## **ADDENDUM # 1**

DATE: May 23, 2025  
TO: Potential Respondents  
FROM: Elaine Robbins – Construction Contract Coordinator II  
SUBJECT: RFCSP752-25-1010ER  
UNT Discovery Park D170 Research Lab Buildout

## ADDENDUM NO. 1

**PROJECT:** UNT Discovery Park D170 Fit-Out  
HE0569.2402.00

P-302

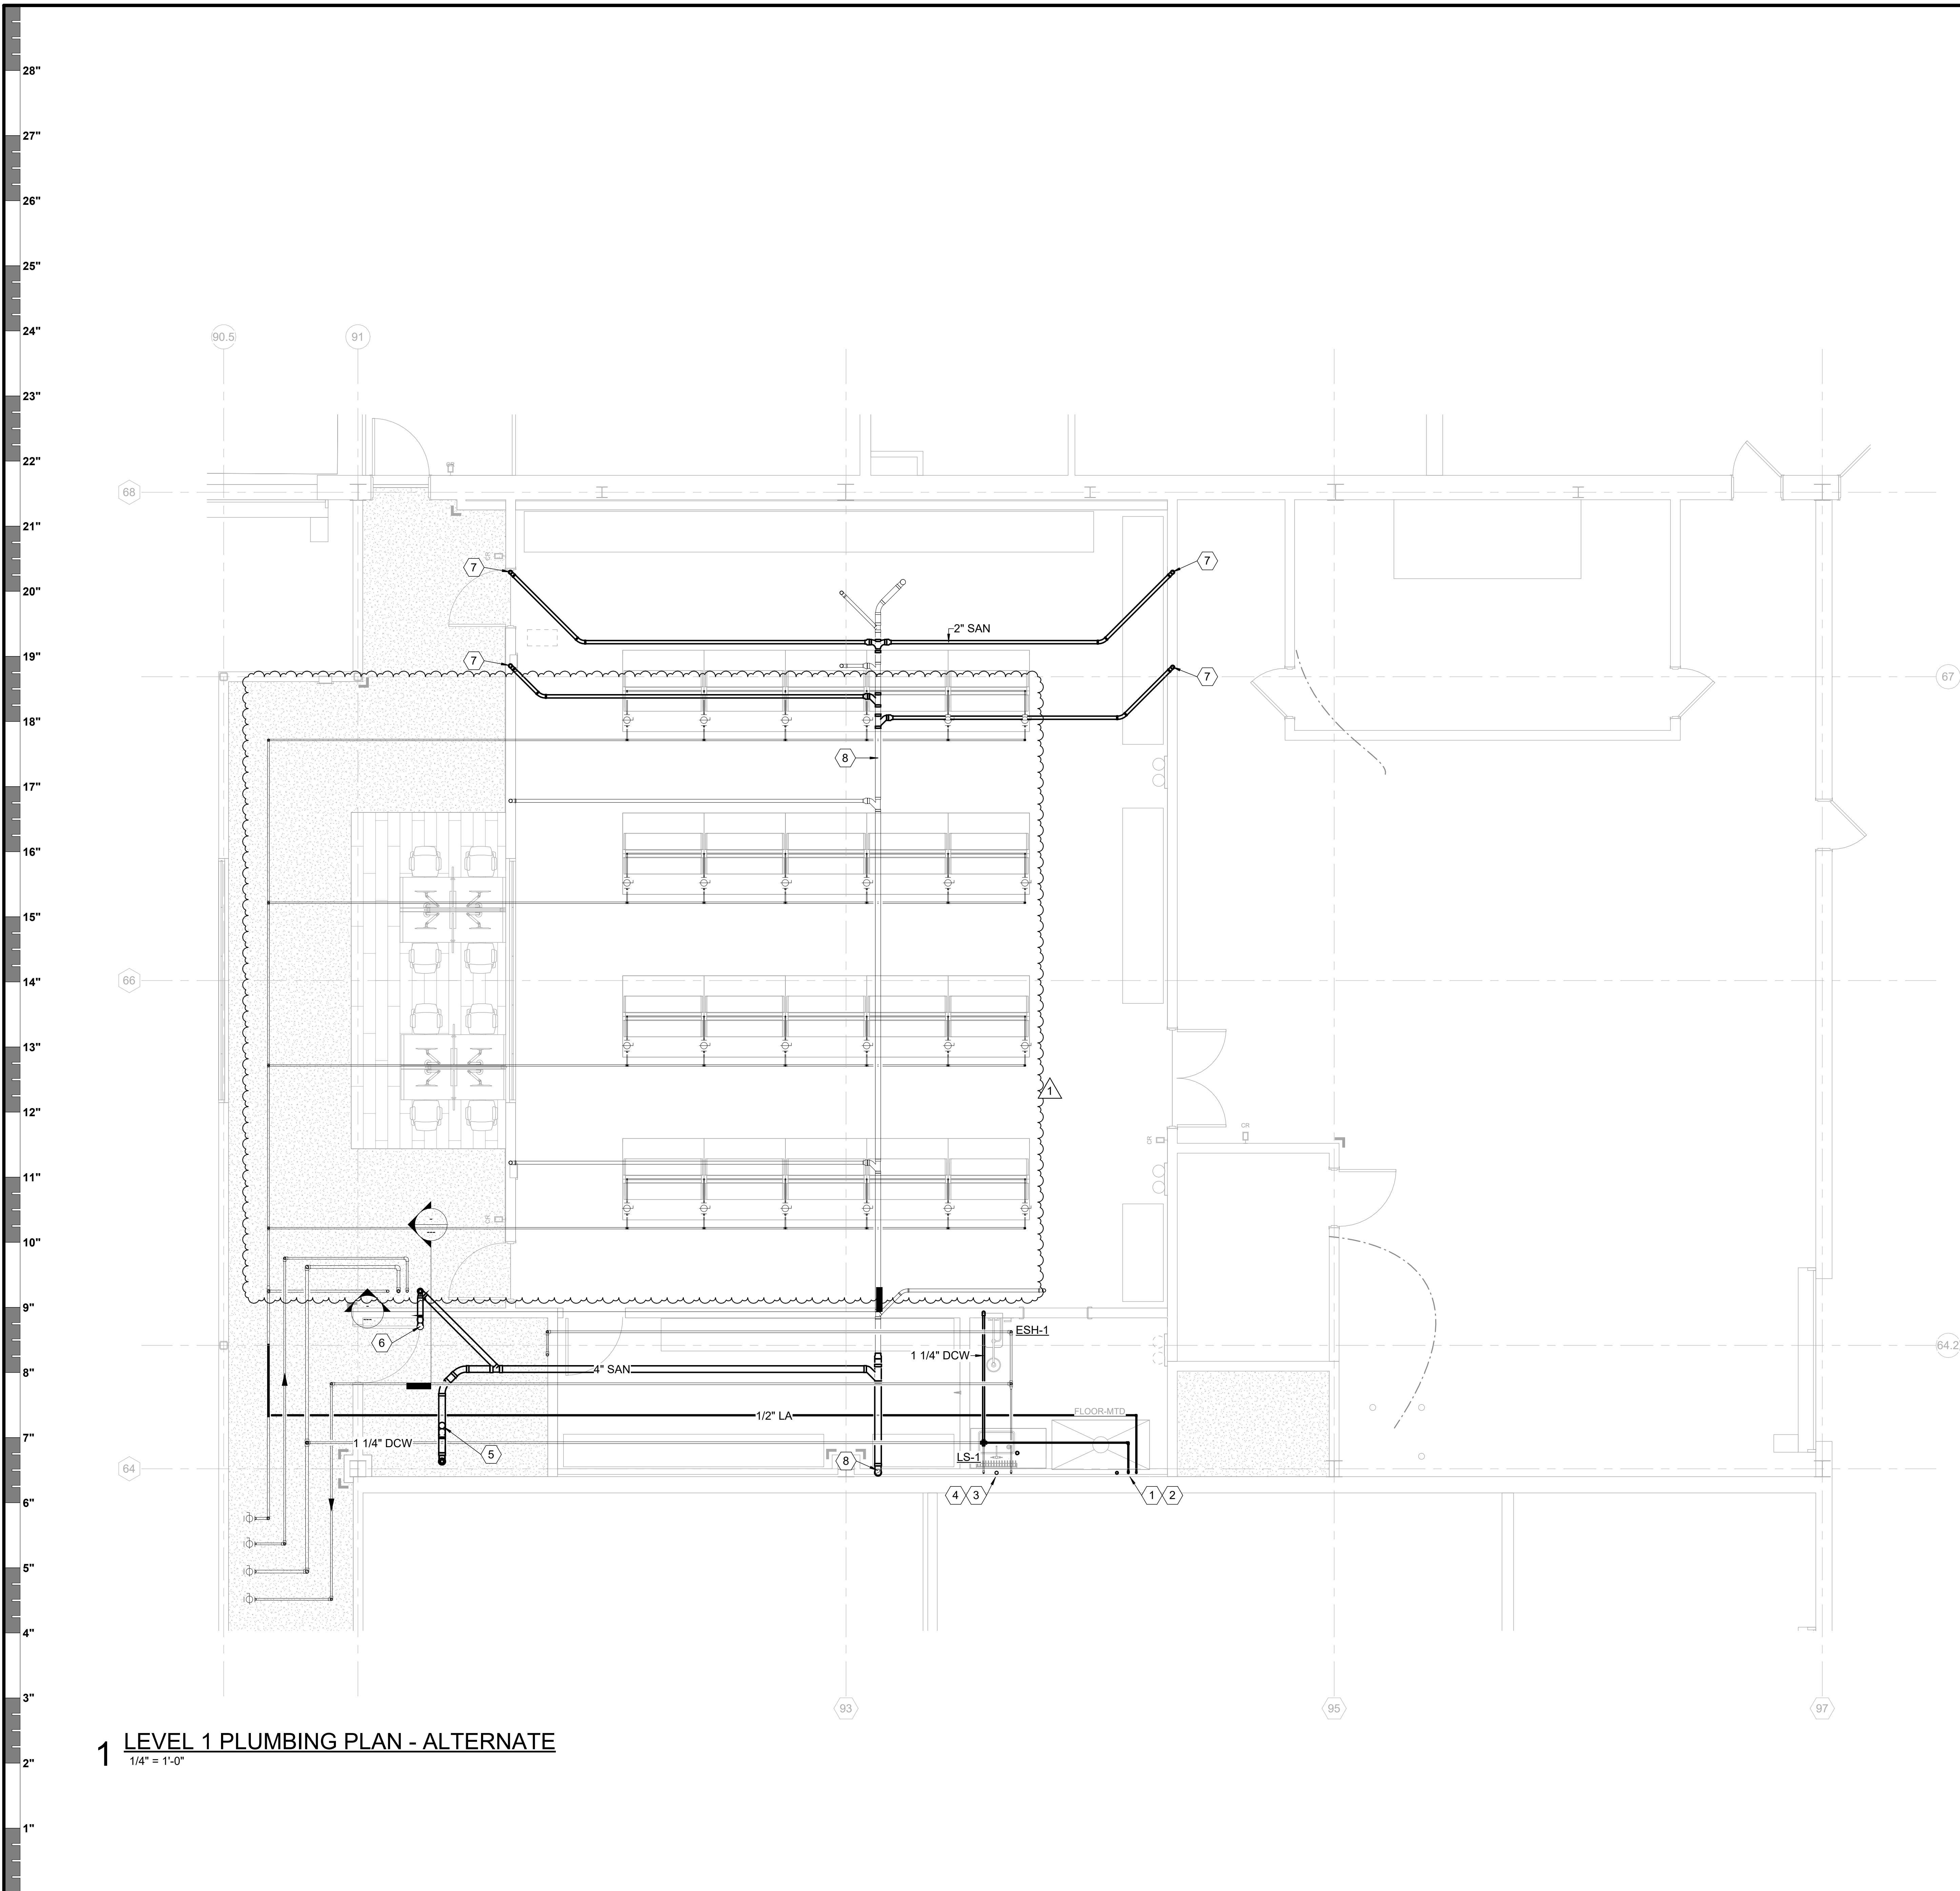
1.14	<p>Q: Plumbing, A805, P-305 - Sheet A-805 shows two (2) LA connections per section in the linear service panels. Sheet P-305 shows one (1) connection per section. Please advise which is correct.</p> <p>A: <b>Overhead piping for lab air routed to linear service panels is in the base bid scope. Plumbing drawings have been updated in this addendum.</b></p>

ITEM	DETAIL
	<p><u>Sheet P-305 - SECOND LEVEL PLUMBING PLAN -ALTERNATE</u> Lab air connections shown in base bid scope at the linear ceiling service panels. RO piping noted as serving autoclave system only.</p> <p><u>Sheet E201 - LEVEL 01 POWER PLAN</u> Linear ceiling service panel outlet locations revised.</p> <p><u>Sheet E202 - LEVEL 02 POWER PLAN</u> Linear ceiling service panel outlet locations revised.</p> <p><u>Sheet E701 - ELECTRICAL PANELBOARD SCHEDULES</u> Circuits 43, 44 clarified on panel LVP-YA12-B. Circuits 2, 4, 6, 8, 10, 12, 14, 16, 18, 20 clarified on panel LVP-YA12-D. Circuits 25, 27, 29 clarified on panel HVP-YA12-M.</p>
	<b>PROJECT MANUAL/SPECIFICATIONS (NEW SPECIFICATION SECTIONS)</b>
